RE: Assessment of Anticipated Visibility Improvements at Surrounding Class I Areas and Cost Effectiveness of Best Available Retrofit Technology for Four Corners Power Plant and Navajo Generating Station: Advanced Notice of Proposed Rulemaking, Docket No. EPA-R09-OAR-2009-0598

**Comments of the Central Arizona Water Conservation District on the
Environmental Protection Agency's Advanced Notice of Proposed Rulemaking
Regarding Best Available Retrofit Technology for Nitrogen Oxide Emissions at the
Navajo Generating Station**

Docket Number EPA-R09-OAR-2009-0598

Figure 1 – Costs to Achieve Incremental Visibility Improvements

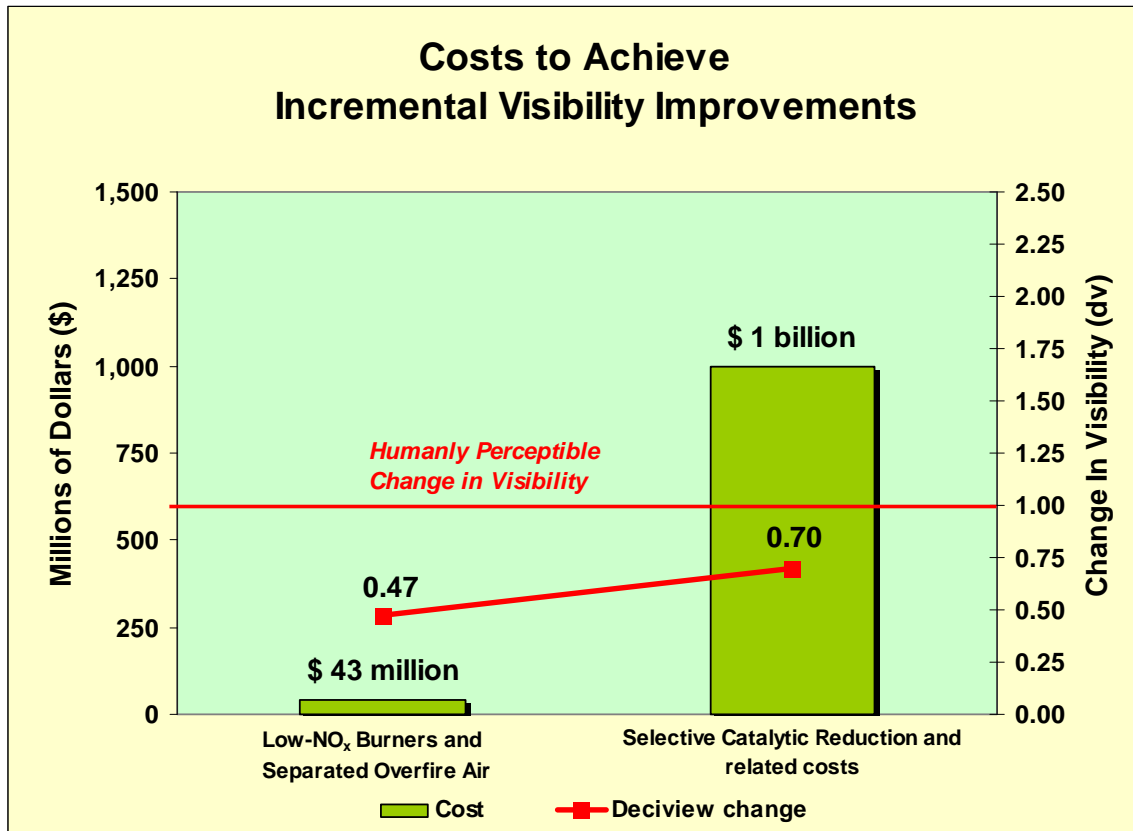
SRP’s studies, which were performed in accordance with EPA’s protocols and approved modeling assumptions, show that the installation and operation of LNB/SOFA will produce, on average, about a half a deciview (0.47 dv) improvement in visibility in nearby Class I areas. Installation of SCRs, in addition to combustion controls, would produce an incremental improvement in visibility, on average, of less than one quarter of a deciview (0.23 dv) – a plainly imperceptible additional improvement – at a cost of another \$660 million to \$1 billion in capital expenses alone. EPA has said that “a one deciview change in haziness is a small but noticeable change in haziness under most circumstances when viewing scenes in a Class I area.”⁷⁹ It is doubtful that either LNB/SOFA or SCR would produce sufficient improvement in visibility to be perceived by the normal observer. But clearly, an investment of as much as \$1 billion to achieve

less than a quarter of a deciview improvement – an indisputably imperceptible change – cannot be justified under any rational cost-benefit analysis.

It is apparent that the incremental visibility benefit that could be achieved using SCRs is insufficient to justify that technology’s enormous additional cost. Under no circumstances could it be concluded that SCRs constitute BART for NGS.
